Date: 02 May 2025

Respond to Request Further Information 2 September 2024

Private Plan Change Request (Ref: PC0003/23) – Coniston Park Ltd, Farm & Racecourse Roads, Ashburton

- Plan OP01 - Outline Development Plan
- Plan OP02 - Outline Development Plan (Cross Section)
- Plan OP03 - Cross Section – Outline Development Plan

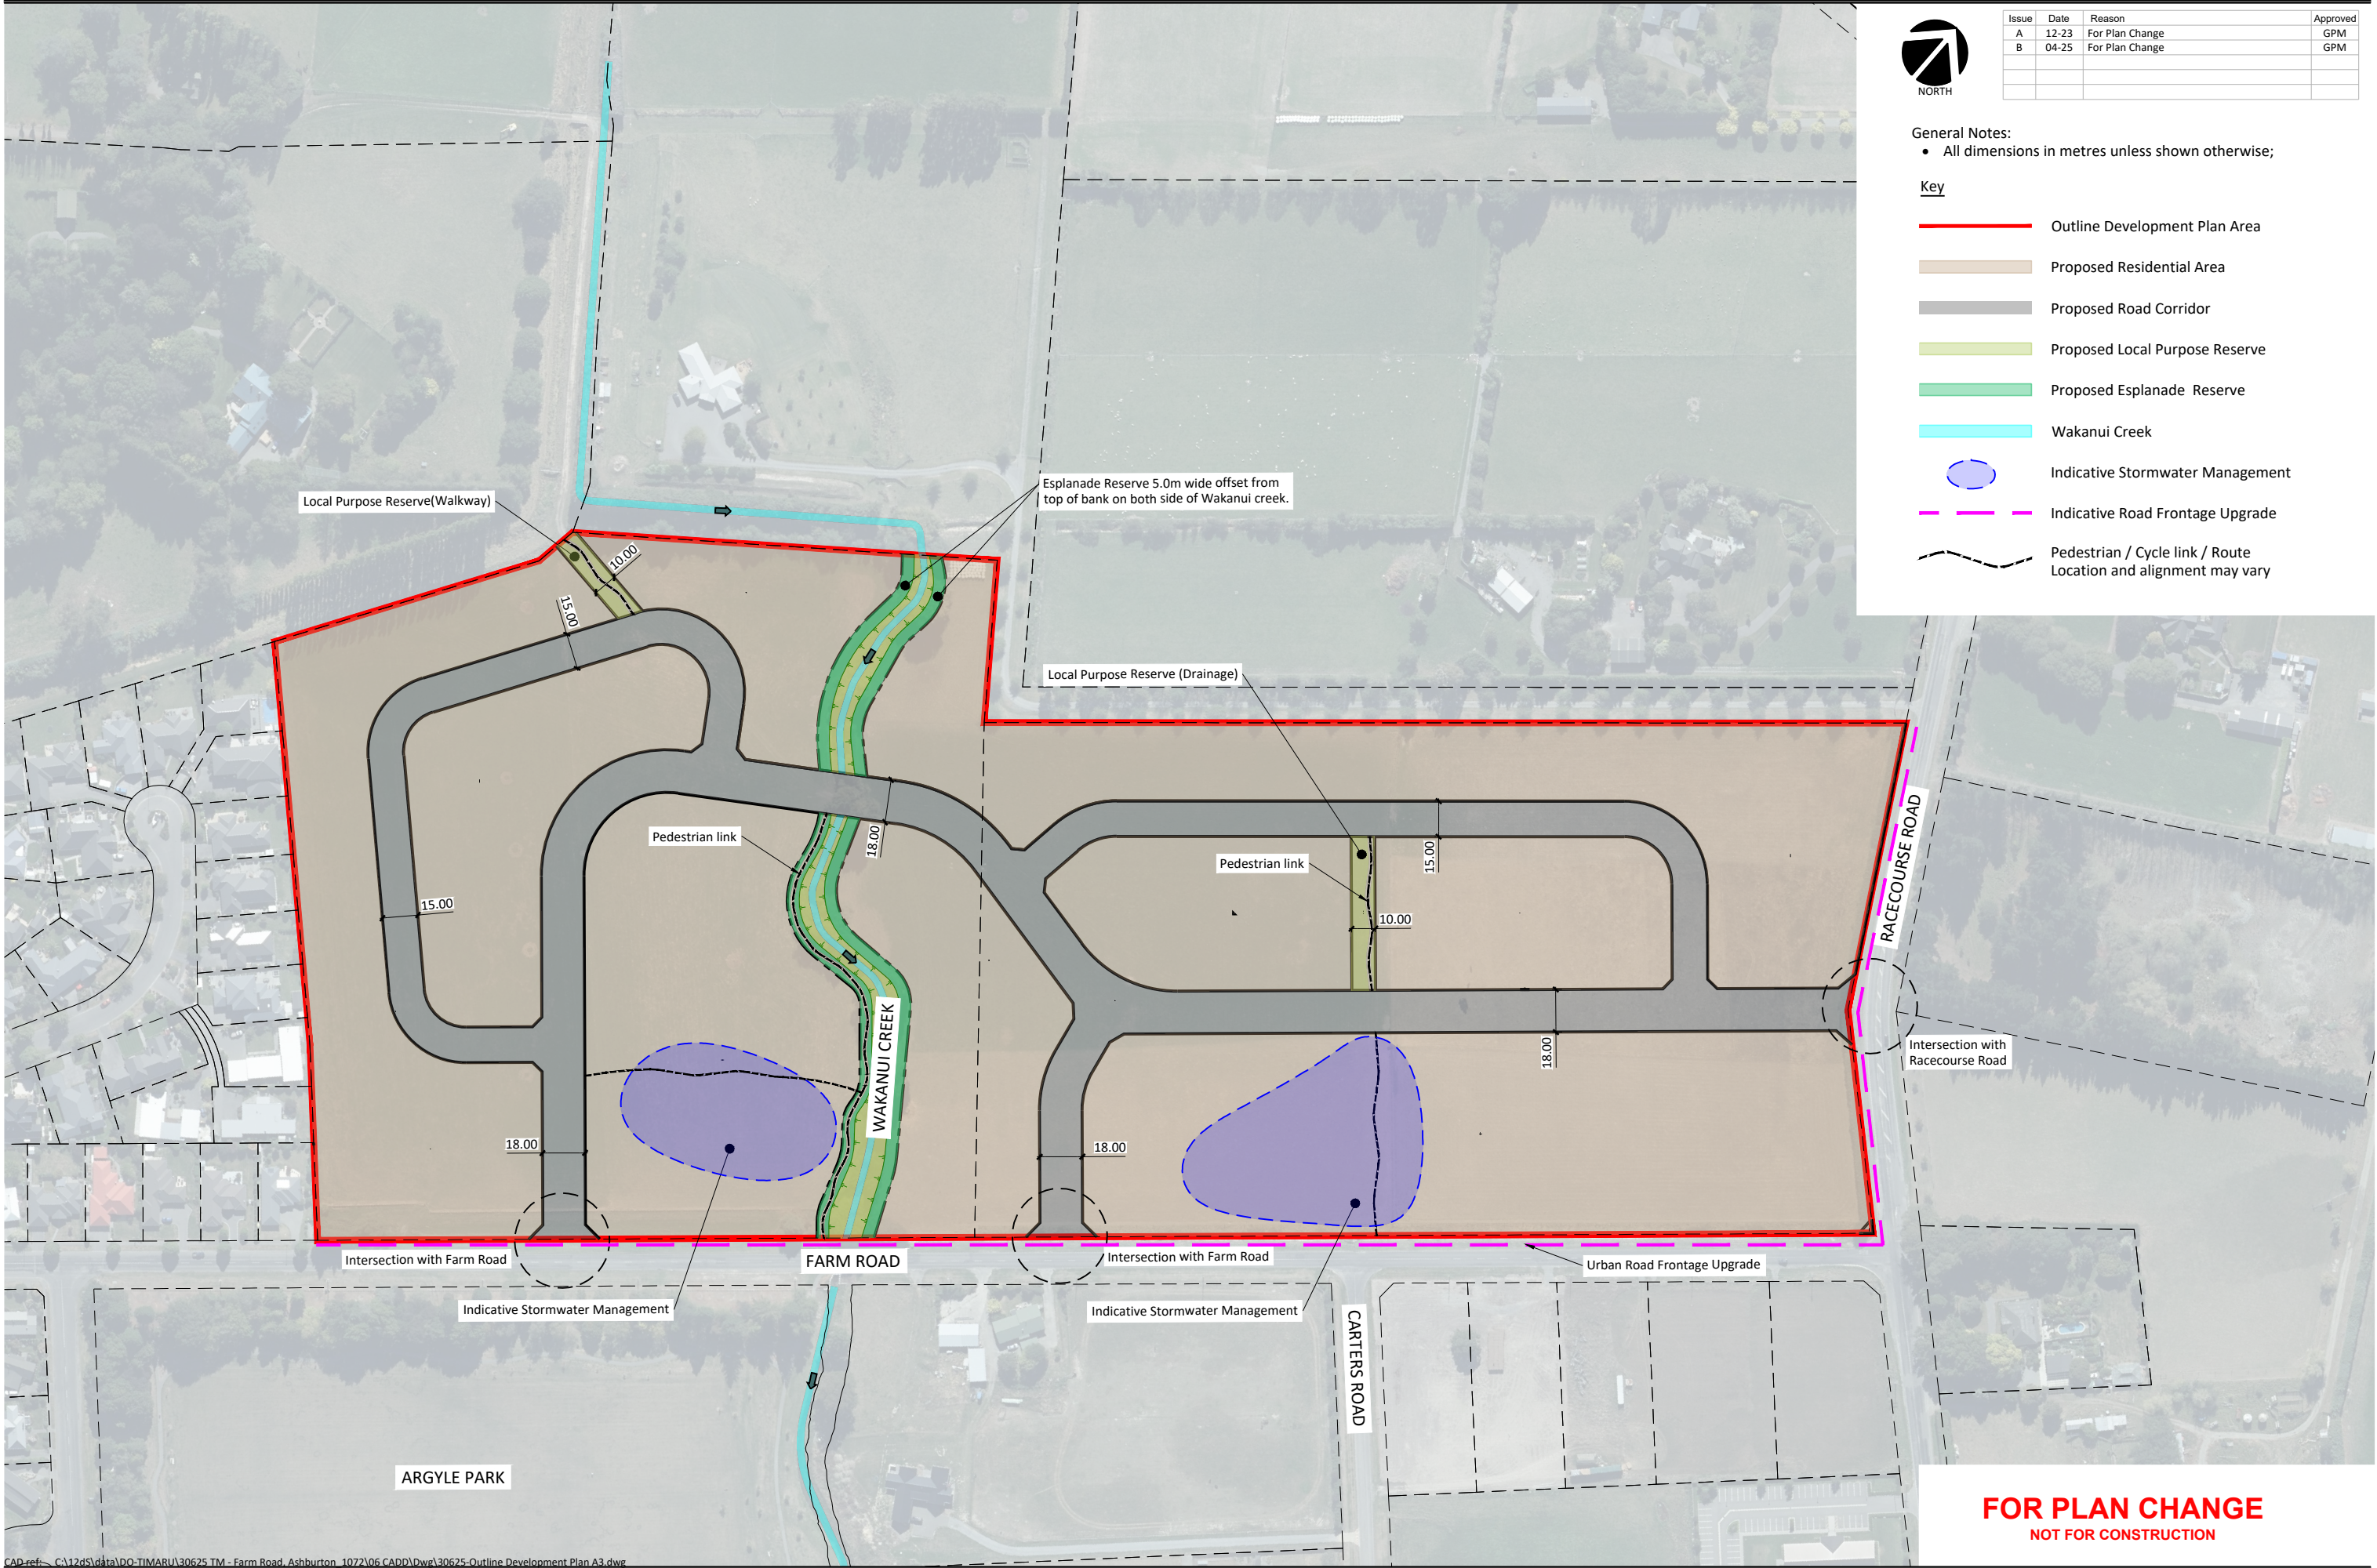
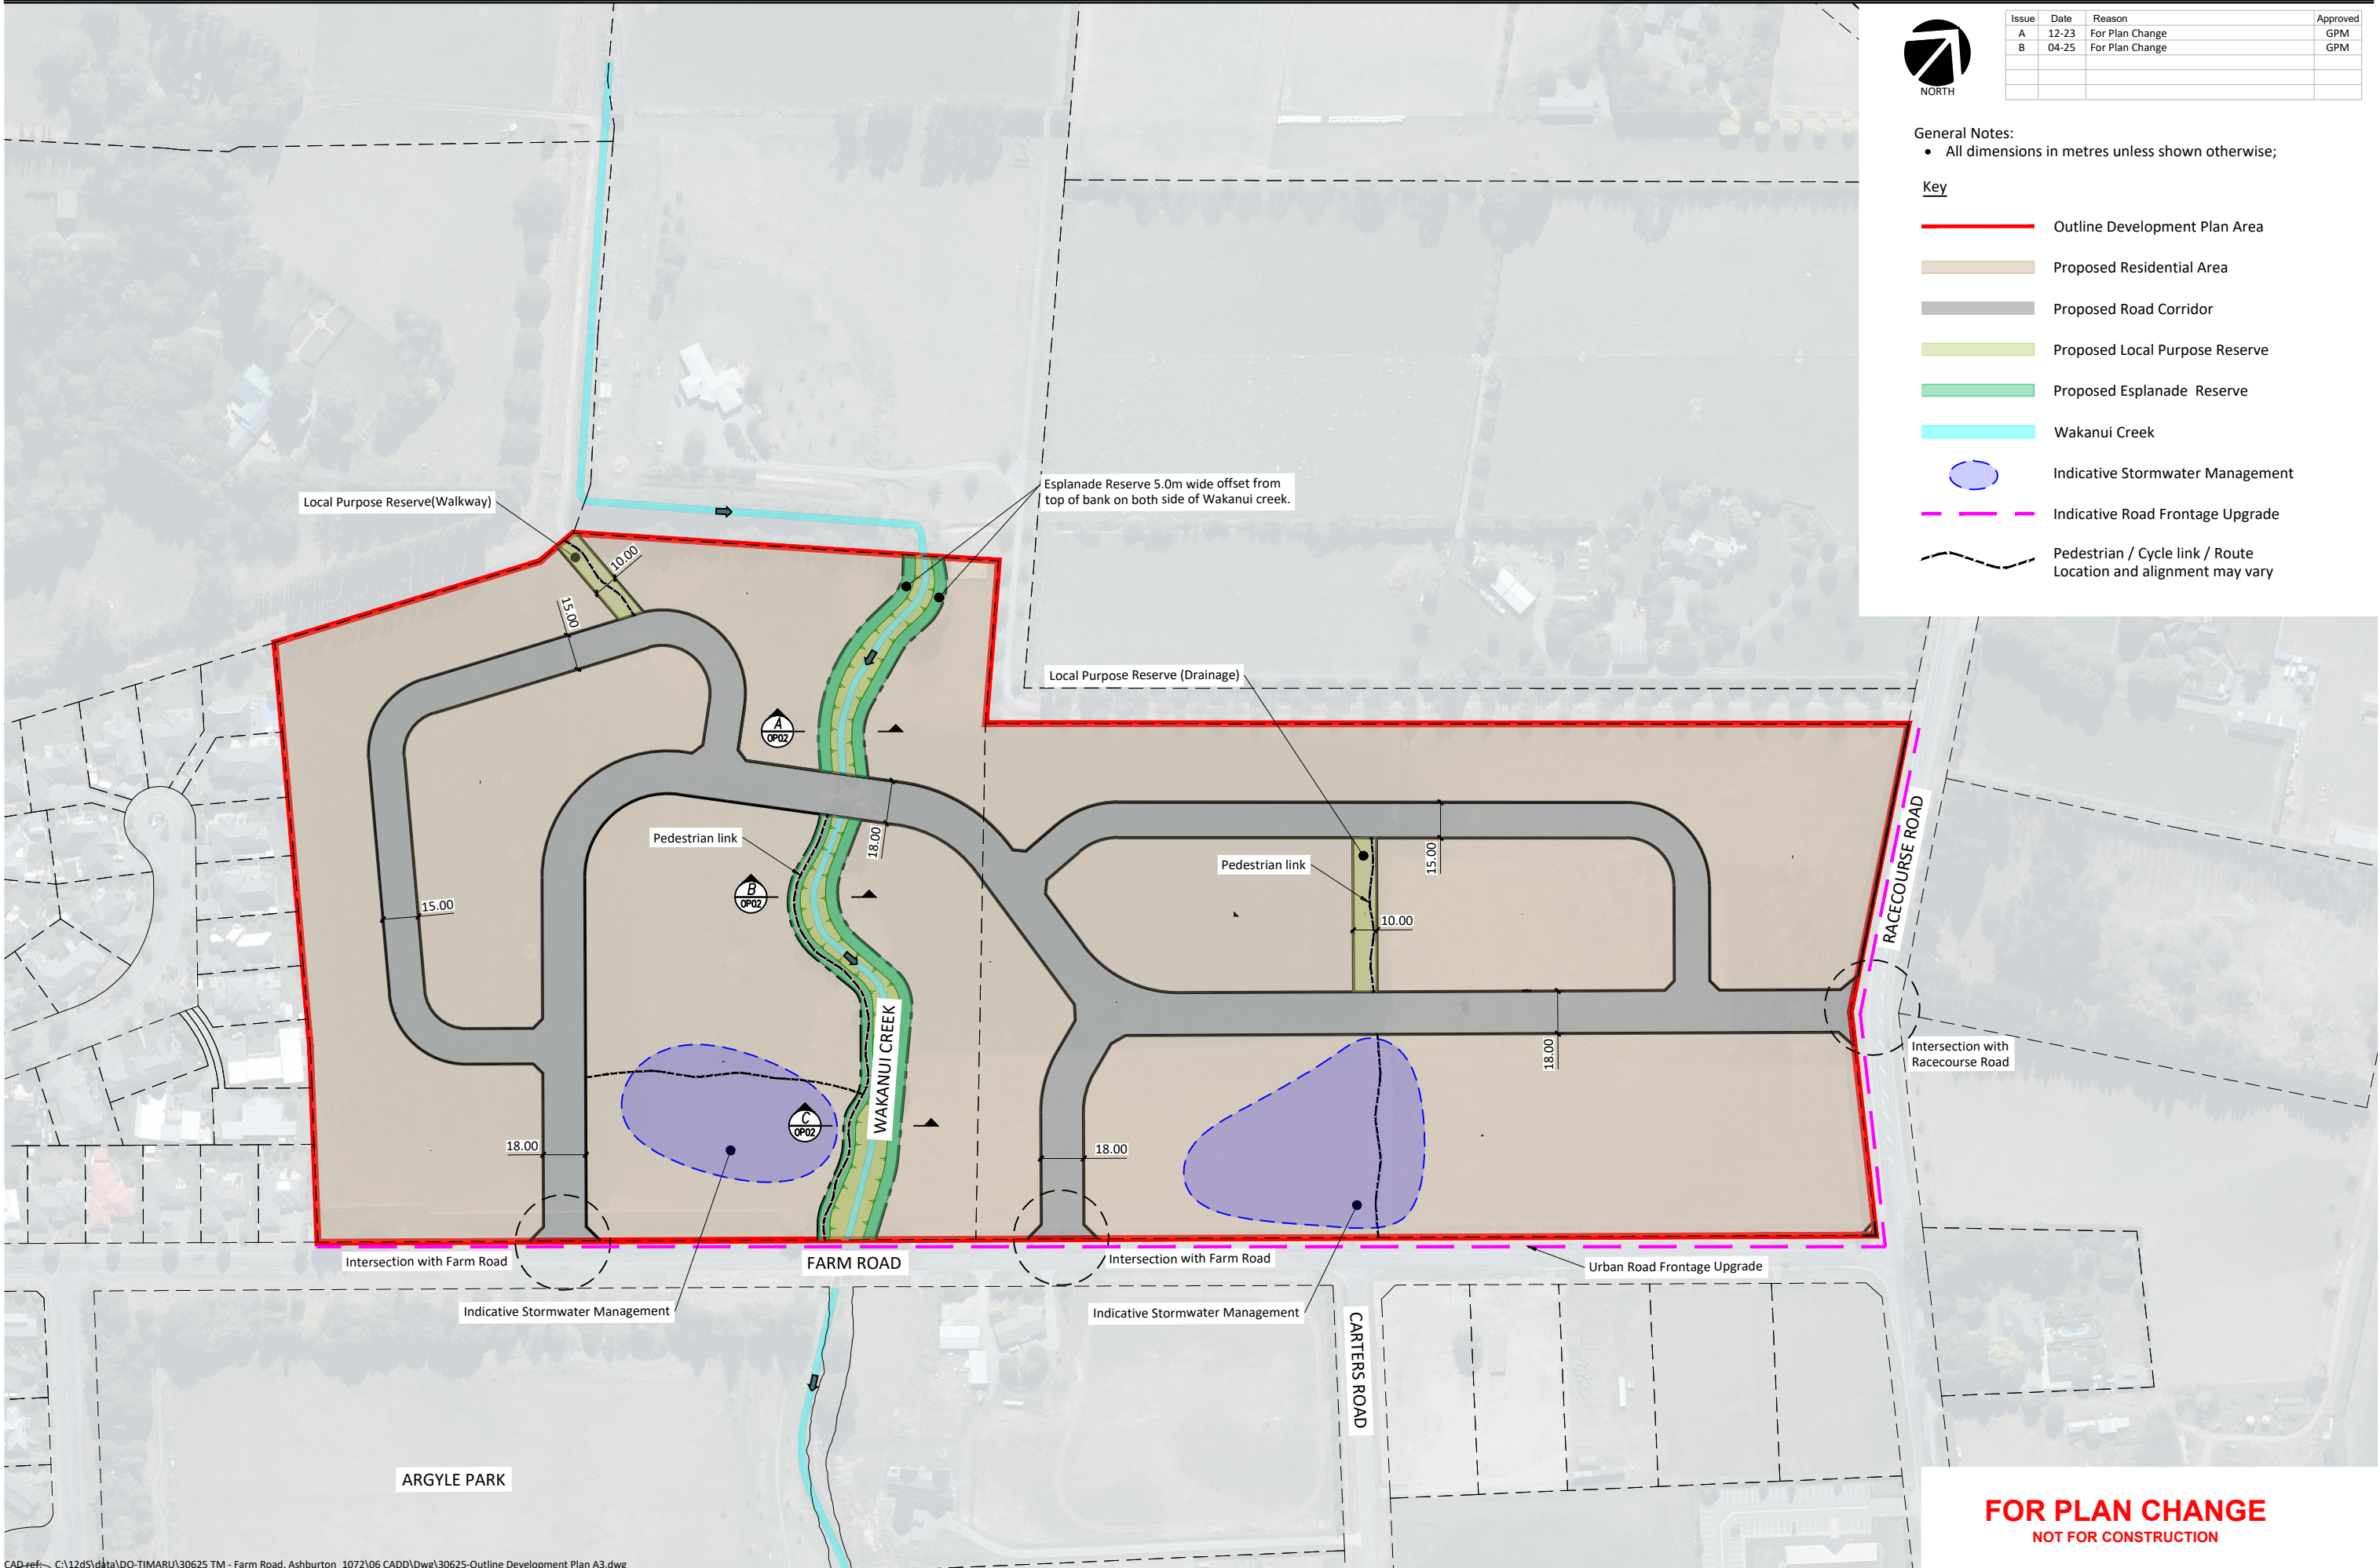
- a. **The way that ‘green areas’ are described and displayed on ODPs can create expectations around what reserves are required by the Council and which ones are eligible for reserve contribution credits. Utility reserves (i.e. local purpose reserves) should be distinguished from esplanade reserves. With respect to recreation reserves, the Council does not consider that any such reserves are appropriate for this development and therefore should not be included in the ODP. To provide certainty for future development, the size of these areas should also be provided on the ODP. Please amend the ODP so there is clear delineation between the various types of reserves proposed. The areas and the widths of these areas should also be included, consistent with the specific requests below.**

- b. **The proposed “Local purpose reserve with indicative pedestrian link to Wakanui Creek” (Lot 302 on the Subdivision Layout Plan) is supported, as this provides an important pedestrian linkage to the Ashburton Lyndhurst Irrigation area. This linkage should be increased to a minimum 10m width to improve its visibility and to be consistent with CPTED principles. It should be labelled as ‘Local Purpose Reserve (Walkway)’ and its width increased to 10m.**

- c. **The proposed open green space beneath the above reserve (Lot 301 on the Subdivision Layout Plan) is not supported and should be removed from the ODP. The rationale for this reserve is not clear. It is considered too small for a neighborhood park and as it is located within the 400m distance from Argyle Park it is considered unnecessary. Please remove this as an open space area on the ODP.**

- d. **The proposed green space (Lot 305 on the Subdivision Layout Plan) is not supported as a reserve area. It is noted that this space is labelled as “potential link to neighboring land” but the Council does not consider this to be necessary as either a pedestrian or roading link. Please remove this as an open space area on the ODP.**

- e. **The primary purpose of the proposed green space link connecting streets (Lot 304 on the Subdivision Layout Plan) appears to be to drain stormwater. The provision of a pedestrian link through this reserve by the developer is supported, but the primary purpose should be reflected through labelling this area as 'Local Purpose Reserve (Drainage)' and details of its width should be included on the ODP.**

- f. **For the proposed indicative stormwater management areas (Lots 300 and 303 on the Subdivision Layout Plan):**
 - a. **the proposed pedestrian cycle link/route provided by the developer through Lot 303 is supported. Lot 300 should have a similar pedestrian link/path on its western boundary connecting the road to the pedestrian link along Wakanui Creek. Please amend the ODP to include this additional pedestrian link.**

- b. **these are shown as stormwater management areas but with reserve areas around the perimeters. As the primary purpose of these lots are for stormwater management they should be shown on the ODP in entirety as either 'Indicative Stormwater Management' or 'Local Purpose Reserve (Stormwater Management)', with the entire area shaded blue.**

Refer to ODP plan in Appendix C. Specific Local Purpose Reserves and esplanade have been distinguished.

Refer to ODP plan in Appendix C. The plan has indicated the linkage to have a minimum 10m width.

Refer to ODP plan in Appendix C. The proposed open green space (Lot 301) has been removed.

Refer to ODP plan in Appendix C. This has been removed and converted to residential area as fee simple title.

Refer to ODP plan in Appendix C. This have been amended to reflect to include the labeling of this area as "Local Purpose Reserve (Drainage)" at a minimum of 10m width.

Refer to ODP plan in Appendix C. This have been amended to have similar pedestrian link / path on its western boundary.

Refer to ODP plan in Appendix C. This have been amended to show "Indicative Stormwater Management."
